Address 1060 Ocean Ave. PERMIT NUMBER 1521

## Remodeling

Location 1056 Ocean Avenue Within Fire Limits? no Dist. No. \_\_\_\_\_  
Owner's name and address Robert Wakefield, 1062 Ocean Avenue Telephone none  
Lessee's name and address \_\_\_\_\_ Telephone \_\_\_\_\_  
Contractor's name and address Owner Telephone \_\_\_\_\_  
Architect \_\_\_\_\_ Specifications \_\_\_\_\_ Plans yes No. of sheets 2  
Proposed use of building Retail store (groceries) No. families \_\_\_\_\_  
Last use \_\_\_\_\_ No. families \_\_\_\_\_  
Material frame No. stories 1 Heat \_\_\_\_\_ Style of roof \_\_\_\_\_ Roofing \_\_\_\_\_  
Other buildings on same lot \_\_\_\_\_  
Estimated cost \$ 1500

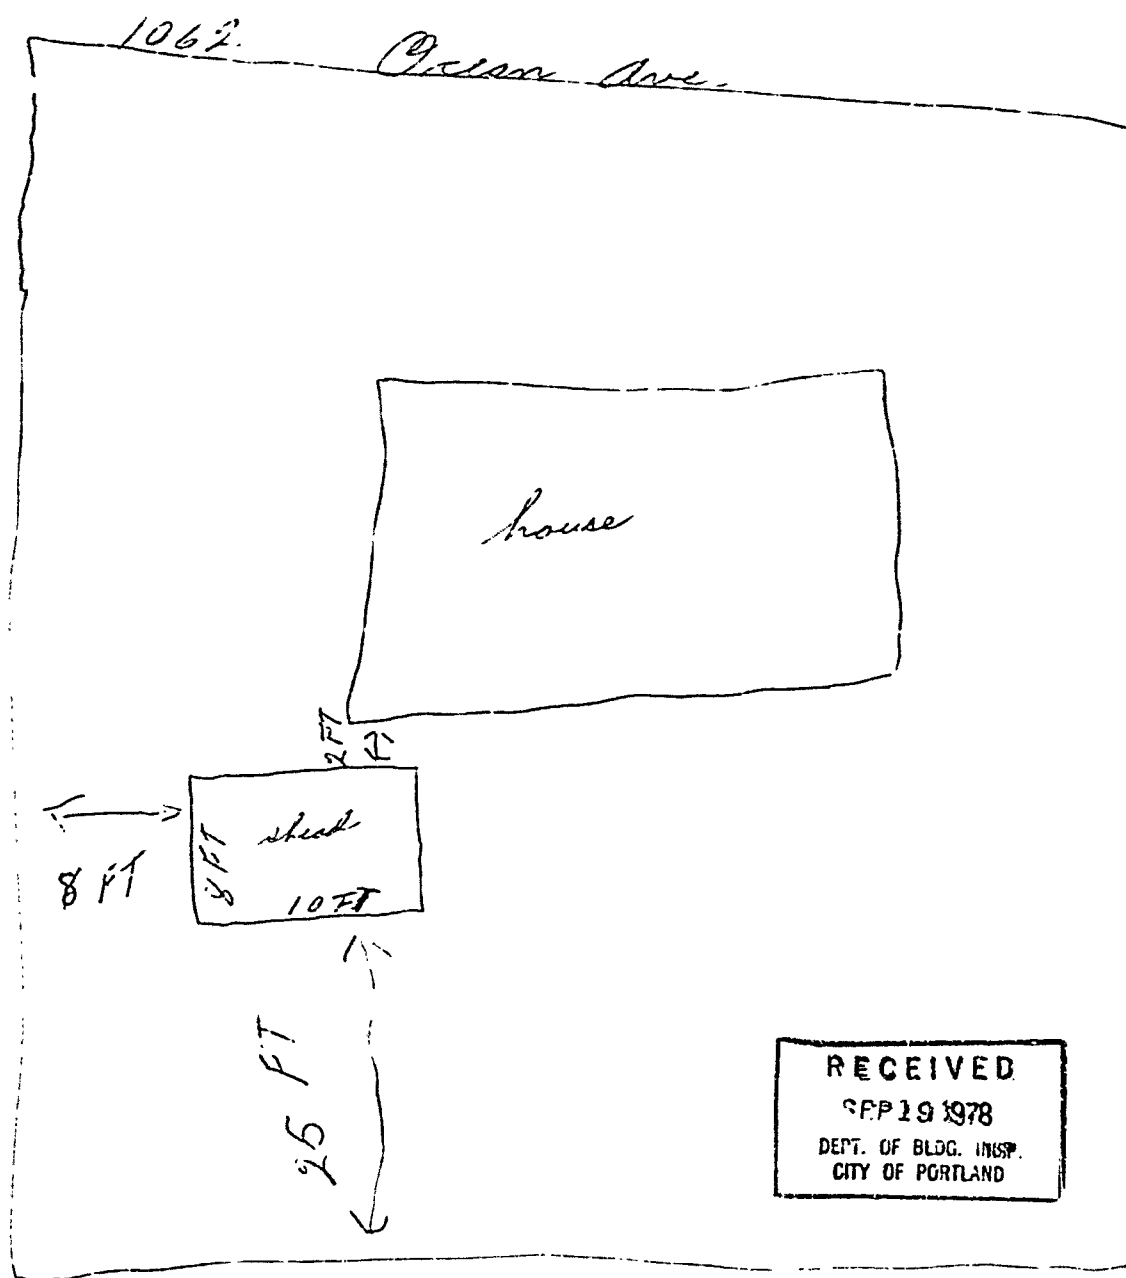
Nothing started, no foundation, no building etc.  
No foundation plan?

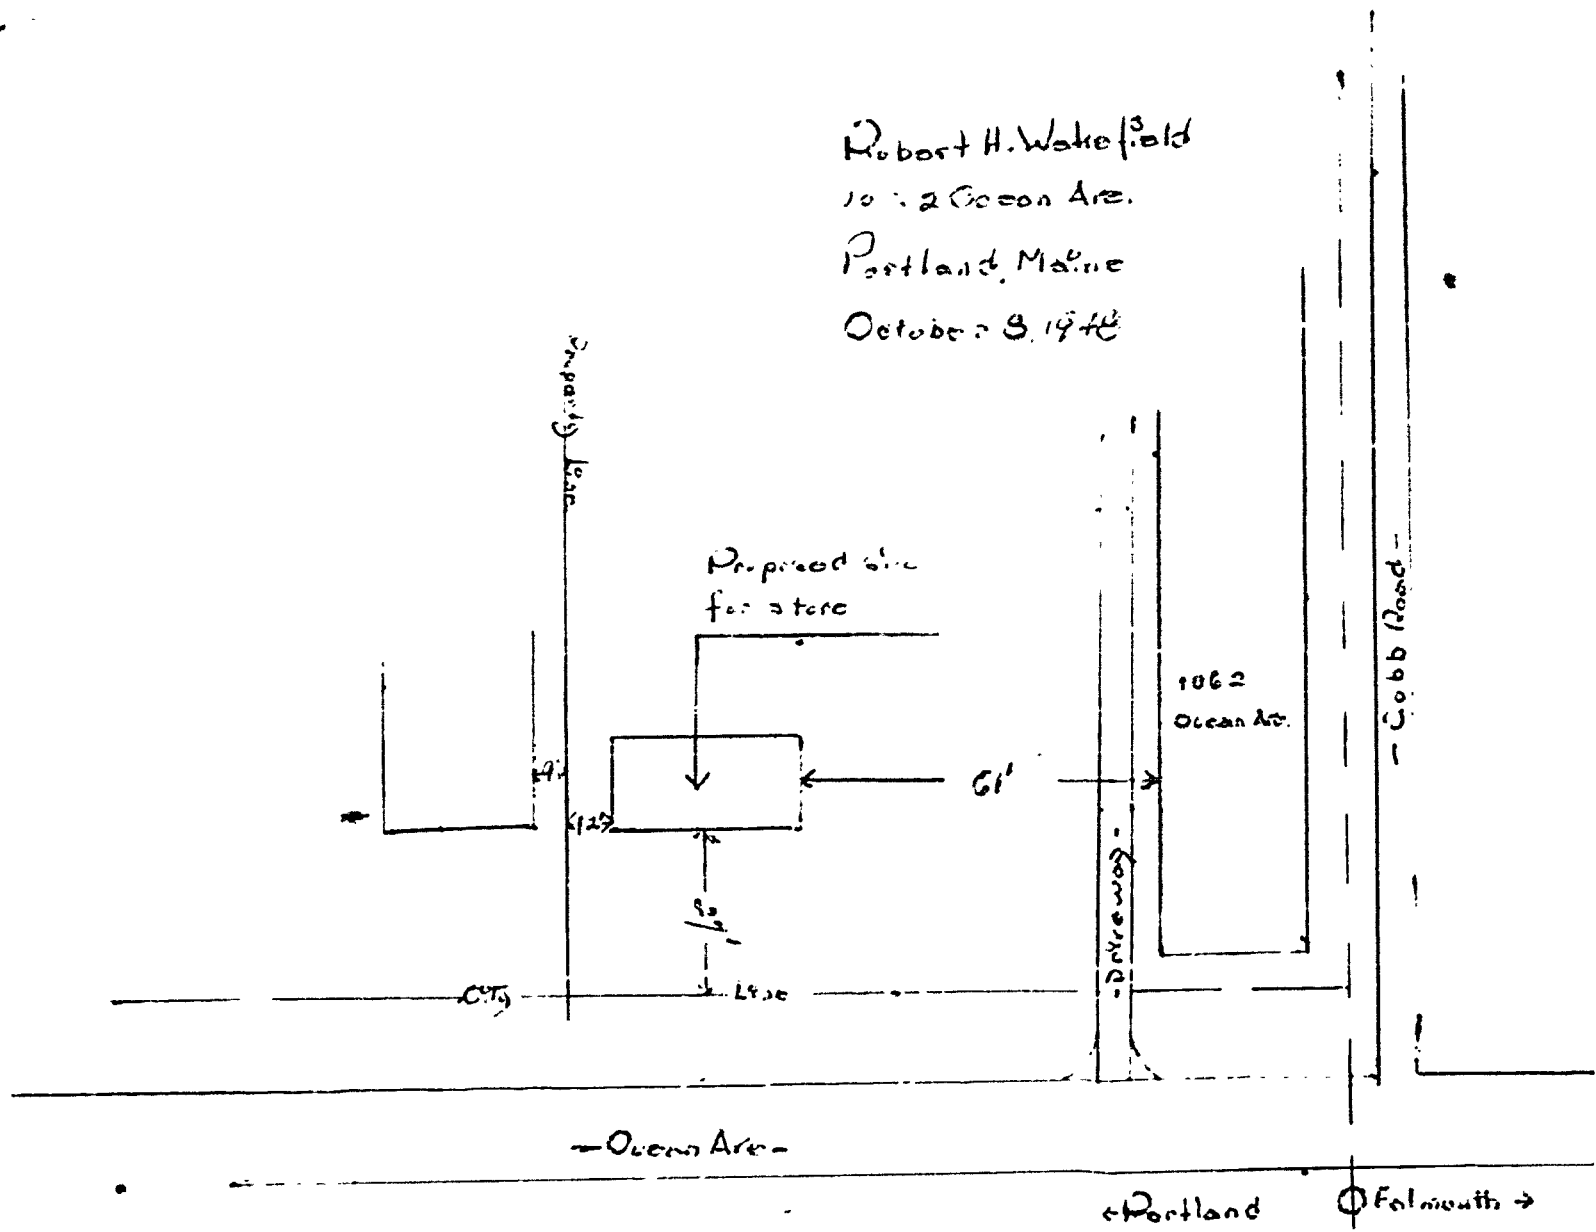
A check of the application in the case filed with it raises the following questions as to compliance with requirements of the Housing Finance and the Building Code:

2. As required by Section 160 of the zoning Ordinance the front wall of the new building may be located no closer to the line of Ocean Avenue than the front wall of the existing dwelling on the adjoining lot. As shown on the plan and shown on plan the proposed location is about three feet nearer Ocean Avenue than the front wall of the dwelling and therefore the location does not comply with the requirement of the zoning Ordinance.

OK. The end sills and girder on spans of more than feet will not figure out to take care of the loads involved wherever the floor and roof joists are to be supported. For a building of this size the building Code specifies a minimum live load capacity of seventy-five pounds per square foot for the floor joists, while that is to be on the flat roof must be figured as forty pounds per square foot. This will necessitate the use of larger timbers for sills and girder or the introduction of more cedar posts to support the EMB's. - *Added to 10-6-62 plans.*

OK. The 2x6 rafters spaced 16" on centers will not figure out on the span of twelve feet unless they are of full size, not dressed, lumber. No less than 1x3 cross bracing, or block bracing the same depth as the rafters, is required at the center of span of rafters. *See drawing 10-108*

4. The end bolsters on top of outer posts between posts and sills as shown on plan are not allowable. The sills are required to rest directly on top of the posts.

5. The finished grade of the ground around the building must be kept at least six inches below the bottom of the sills instead of part way up on walls of building as shown on plan.

If splicing of sills is necessary, such splices are required to come directly over the cedar posts and to be lapped at least eight inches instead of being butted as indicated on plan.

Before we shall be able to issue a permit for construction of this building, it will be necessary that the location of the building be staked out in a position complying with Zoning Ordinance regulations and that the plan be revised to show compliance with Building Code requirements in the particulars listed above. A copy of this letter is being enclosed for use of your architect should you care to give it to him.
